**BEFORE THE IDAHO PUBLIC UTILITIES COMMISSION**

**IN THE MATTER OF IDAHO )**  
**POWER COMPANY'S )**  
**APPLICATION TO COMPLETE )**  
**THE STUDY REVIEW PHASE OF ) CASE NO. IPC-E-22-22**  
**THE COMPREHENSIVE STUDY OF )**  
**COSTS AND BENEFITS OF ) CLEAN ENERGY OPPORTUNITIES**  
**ON-SITE CUSTOMER ) FOR IDAHO - REPLY COMMENTS**  
**GENERATION & FOR AUTHORITY )**  
**TO IMPLEMENT CHANGES TO )**  
**SCHEDULES 6, 8, AND 84 )**  
**)**

<b>IN THE MATTER OF IDAHO POWER COMPANY'S</b>	)	<b>IPC-E-22-22</b>
<b>APPLICATION TO COMPLETE THE STUDY REVIEW</b>	)	
<b>PHASE OF THE COMPREHENSIVE STUDY OF COSTS</b>	)	<b>Clean Energy</b>
<b>AND BENEFITS OF ON-SITE CUSTOMER GENERATION</b>	)	<b>Opportunities for</b>
<b>&amp; FOR AUTHORITY TO IMPLEMENT CHANGES</b>	)	<b>Idaho - Reply</b>
<b>TO SCHEDULES 6, 8, AND 84</b>	)	<b>Comments</b>

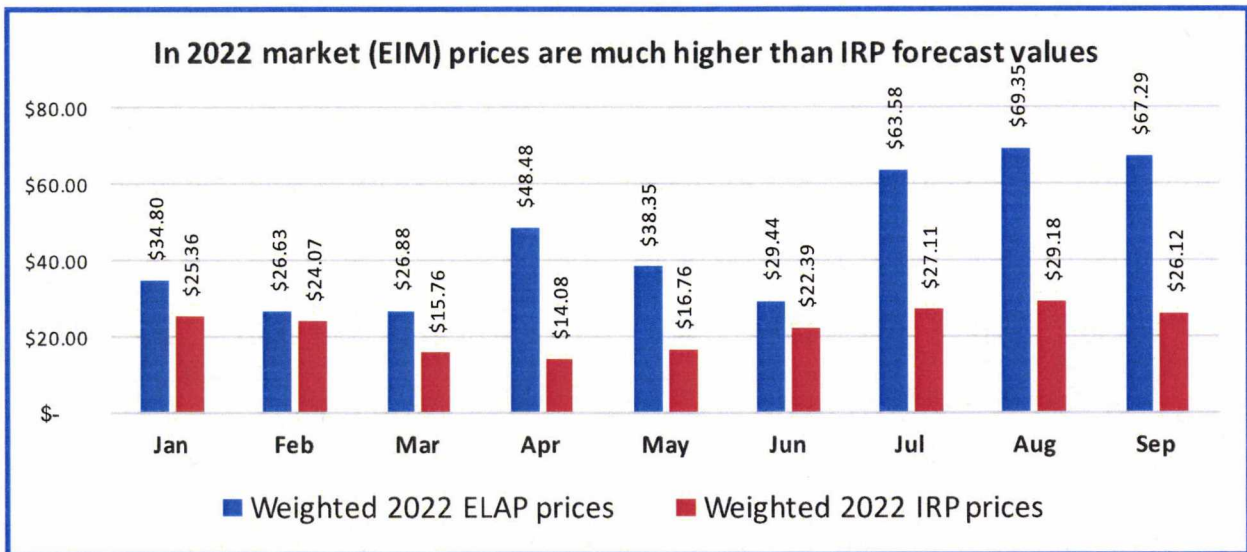
The substantial difference between IRP estimates and actual market prices was evidenced in recent responses to production requests. Using data supplied in response to a production request for 2022 ELAP hourly prices through September of this year and PVWatts solar production estimates<sup>2</sup>, CEO displays in the chart below the dramatic inaccuracy of the IRP hourly price forecasts for 2022 by comparing them to the actual market prices that have occurred thus far in 2022.

▶ VODER update #1. 2022 IRP forecast hourly prices are dramatically different than actual market prices. To meet Commission direction for use of “the most recent data”, the updated VODER needs to show how different (and thus more fairly reflective of the true value provided to the IPC system) Avoided Energy values would be using either the ICE or ELAP data sources of actual 2022 market prices than by using outdated 2022 IRP forecast values.

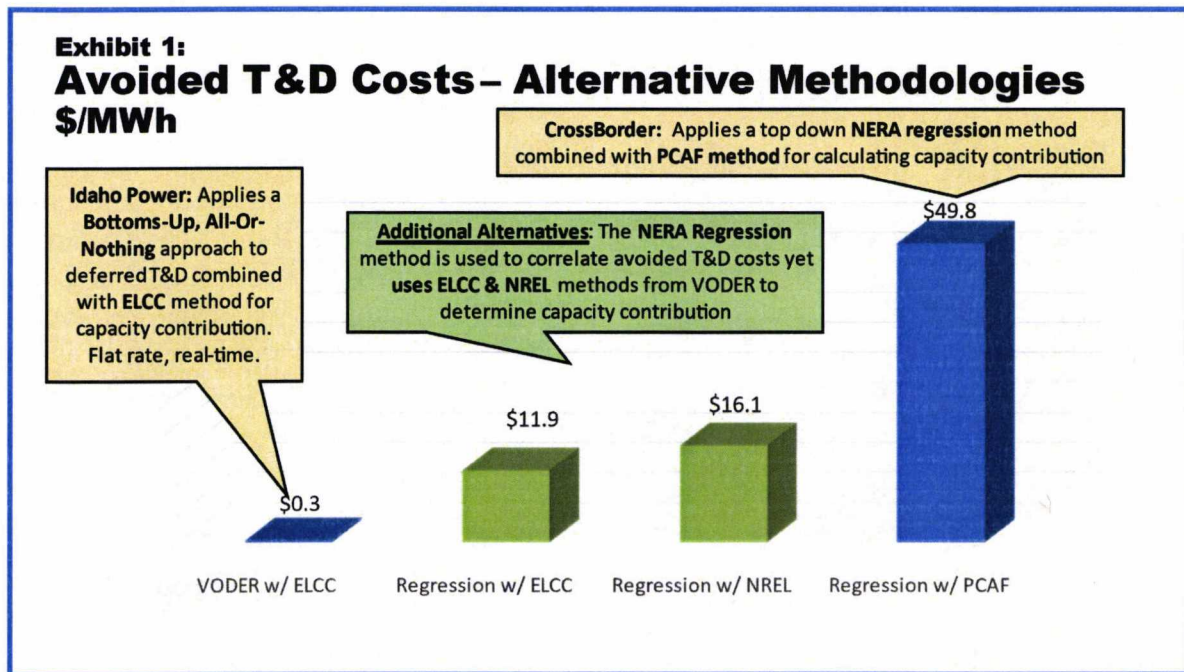
With regard to the methodology for determining avoided T&D costs, the NERA method is more stable and accurate than the project-specific, all-or-nothing method used in VODER. The Company’s criteria are unreasonable to require that the quantity of the exports would need to be sufficient to exceed the planning capacity shortfall for a specific project in order for any capacity value to be assigned. Exports *do contribute* to the deferral of T&D and increase the probability that costs can be deferred. Further, as described in prior comments<sup>13</sup>, the Company’s all-or-nothing approach can result in extremes.

As illustrated in Exhibit 1 below (see Attachment 1 for calculations), different analytical methods can produce dramatically different estimates of the appropriate T&D capacity value. The VODER study should display this range of alternate valuations.

- ▶ VODER update #7. CEO believes the updated VODER study should present the option of utilizing the NERA method for valuing avoided T&D in combination with the ELCC, NREL, and PCAF methods for calculating T&D capacity contribution values.
